UNITED STATES PATENT AND TRADEMARK OFFICE

APPLICATION NO.	FILING DATE	FIRST NAMED INVENTOR	ATTORNEY DOCKET NO.	CONFIRMATION NO.
10/049,862	02/19/2002	Max Roth	032553-021	2349
21839	7590	08/25/2005	EXAMINER	
BUCHANAN INGERSOLL PC (INCLUDING BURNS, DOANE, SWECKER & MATHIS) POST OFFICE BOX 1404 ALEXANDRIA, VA 22313-1404			DUONG, THO V	
			ART UNIT	PAPER NUMBER
			3743

Office Action Summary	Application No.	Applicant(s)	
	10/049,862	ROTH, MAX	
	Examiner	Art Unit	
	Tho v. Duong	3743

DETAILED ACTION

FIGURE A: THE MODIFIED FIGURE CORRESPONDES TO FIGURE 4 WITH LIMITATIONS SHOWN

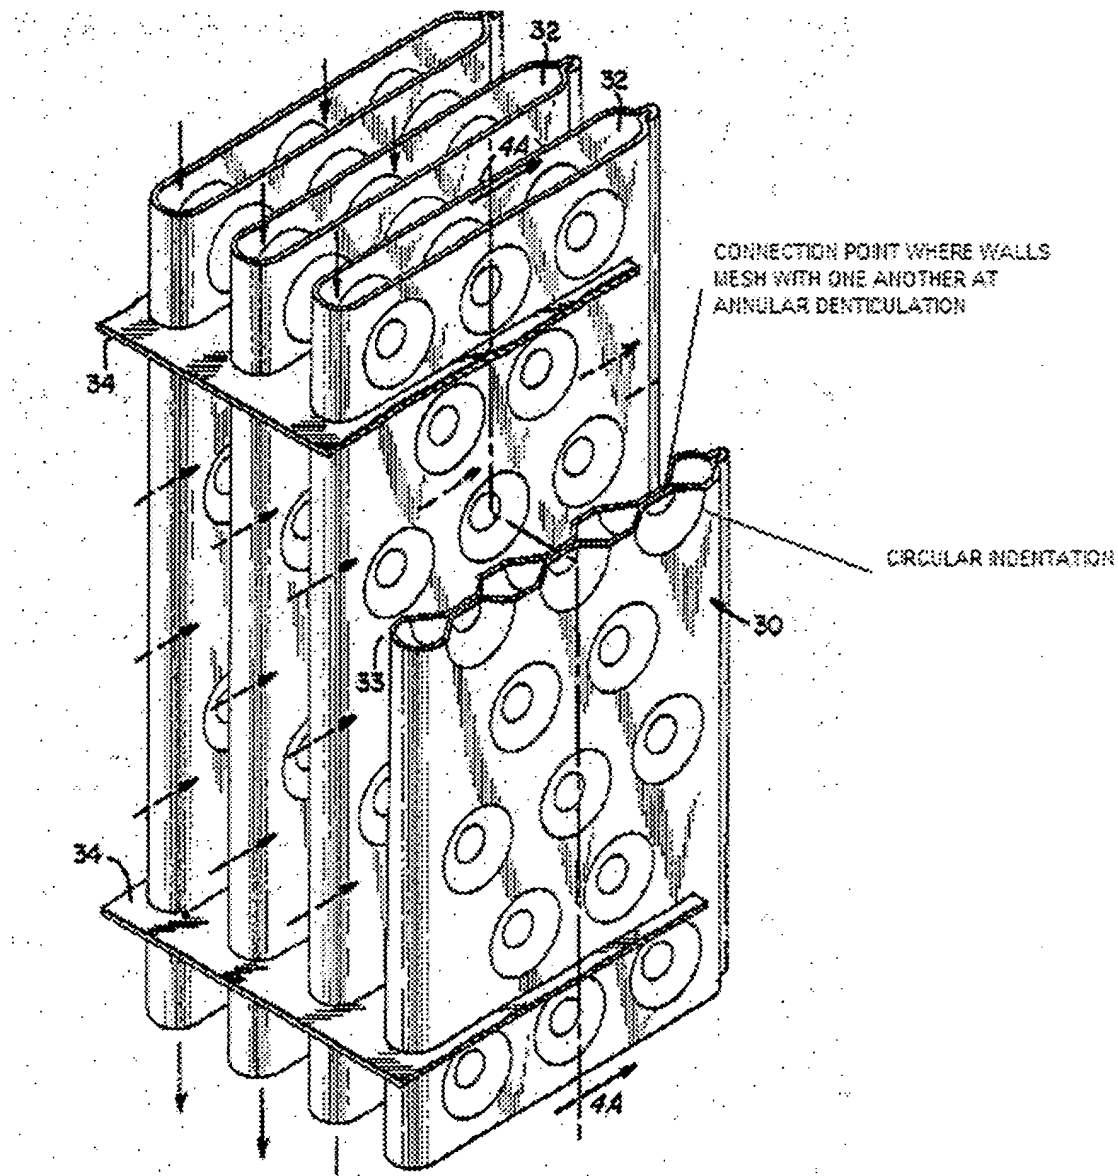
Claims 8,10-14,17,19,22-23 and 26 are rejected under 35 U.S.C. 102(b) as anticipated by or, in the alternative, under 35 U.S.C. 103(a) as obvious over Kun (US 3,757,855). Kun discloses (figures 2a, 4,4a and column 6, lines 37-47) a construction kit for a radiator cooling system comprising a plurality of heat exchangers (30); plug connectors (8) for the connection of the heat exchanger; and a tank (10), which is capable of containing hot water. The heat exchanger (21) comprising a two joined together copper walls, which has a thickness of 0.076-6.35 mm, forming a flow through chamber (32) for a heat transfer medium, the walls being joined together at a plurality of connecting points (22) inside a surface between edges of the heat exchanger, wherein the wall mesh with one another at the connecting points (Figure A). Kun further discloses that the annular denticulations are spaced apart at a distance D from 5 mm to 63 mm. The method of forming the device "punctuate fastened", "compression molded annular denticulations" and "are produced by an upsetting-pressing process and without penetration of sheet metal used to form the walls" are not germane to the issue of patentability of the device itself. "[E]ven though product-by-process claims are limited by and defined by the process, determination of patentability is based on the product itself. The patentability of a product does not depend on its method of production. If the product in the product-by-process claim is the same as or obvious

In this case, the heat exchanger in the product-by-process claim is the same as or obvious from the heat exchanger of the Kun, the claim is unpatentable even though the prior heat exchanger was made by a different process.
